Re: GMC Powertrain Saginaw Metal Casting Operations, MID-041-793-340
RCRA Facility Investigation Phase 1C Report
Responses to U.S. EPA Comments Dated May 24, 2007

**RESPONSES TO
U.S. EPA COMMENTS DATED MAY 24, 2007 ON THE
RCRA PHASE 1C RFI REPORT (REVISED) DATED MARCH 9, 2007**

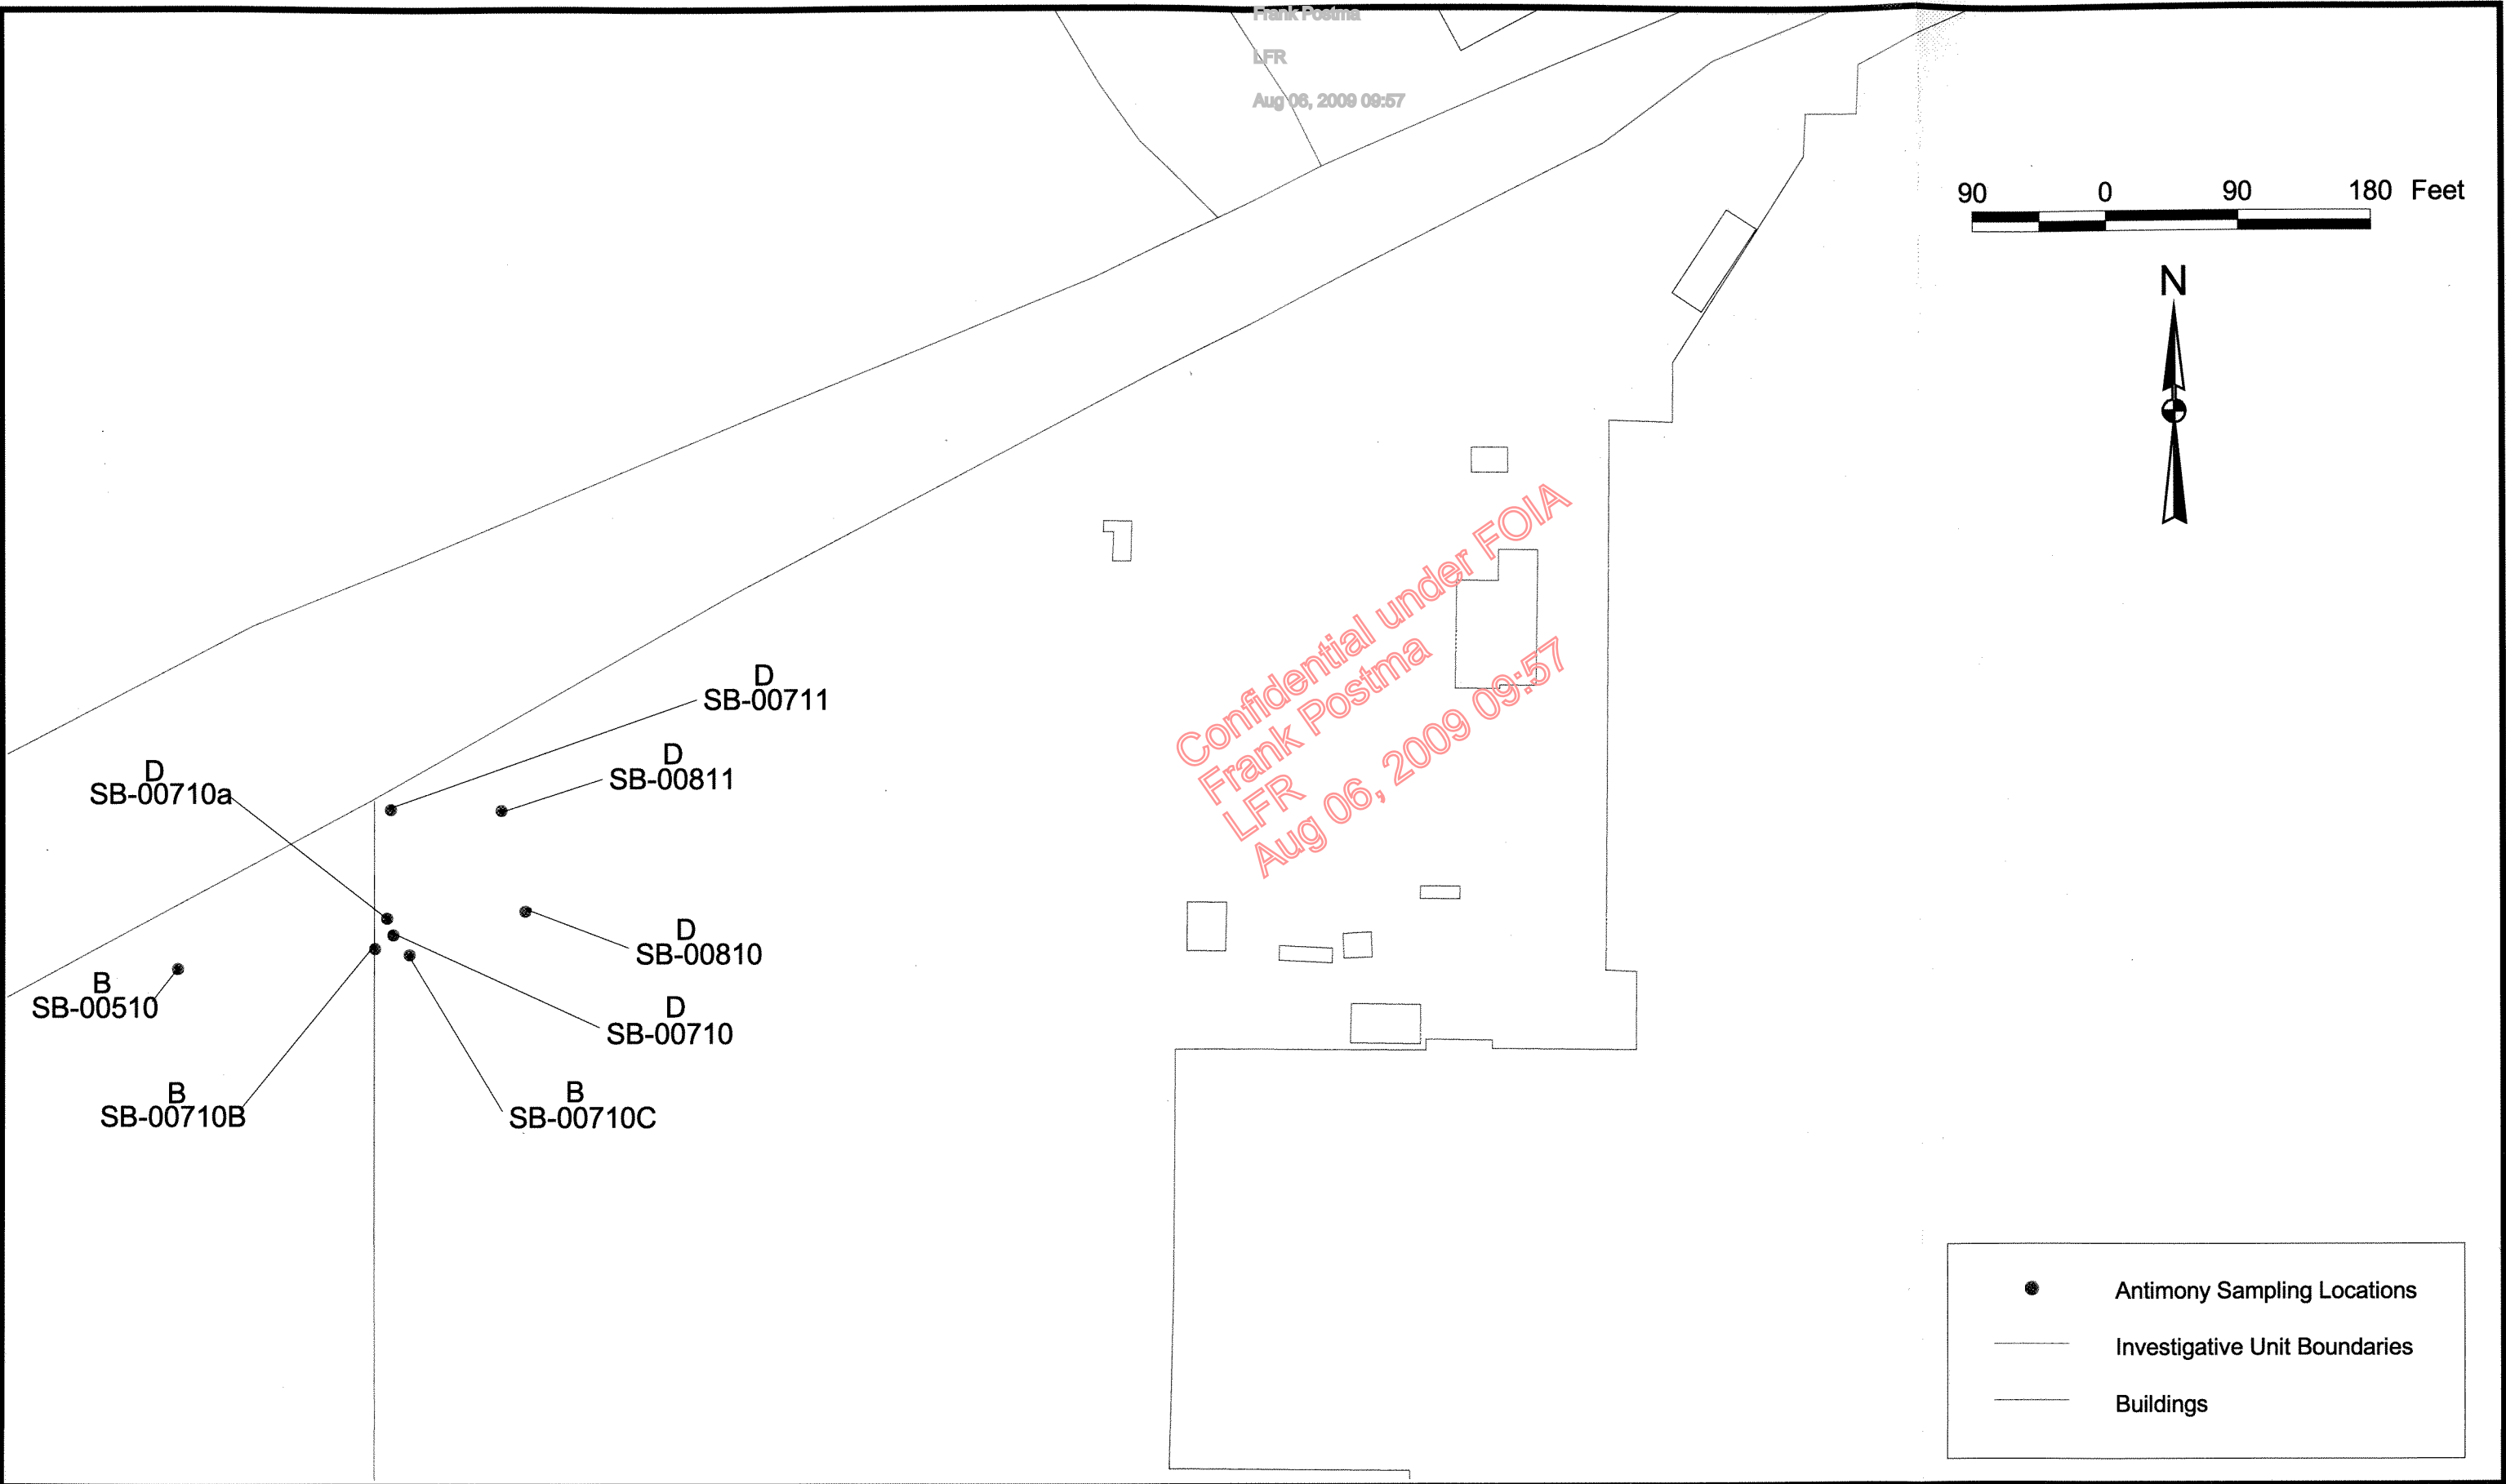
Page A-45/Page A-46/Table A5-2: Please explain and justify the approach specified in the following statement- "In certain cases, these estimates were conservatively based on RFI data collected in the area immediately surrounding the location exhibiting the highest concentrations of one or more of these constituents (i.e., delineation data) rather than all data across the exposure area." The site conceptual model does not match the text on this point. Please justify why it was appropriate to divide IU D into exposure areas.

The text cited in this comment was referring to the calculation of 95% UCLs that used data from only the portion of an exposure area that is in the vicinity of the highest detected concentration. As noted in the text, this approach is conservative, because it calculates the 95% UCL by combining the highest concentration with fewer lower concentrations than are available in the whole exposure area. By using fewer lower concentrations, the resulting 95% UCL will be higher, or more conservative, than a 95% UCL that is calculated using additional lower concentrations measured across the entire IU.

This approach was applied as a conservative measure to calculate 95% UCLs for constituents in outdoor soil at IU D, because IU D is large (approximately 66 acres) and contains the active SMCO plant building, which extends essentially from the northern boundary of the unit to the southern boundary. The configuration of the outdoor areas is such that workers could be predominantly exposed to outdoor soil on one side of the building. As such, calculating a 95% UCL using data from only one side of the building around the highest concentration gives a higher or more conservative 95% UCL. The samples used for this calculation are shown on Figure 2 (attached).
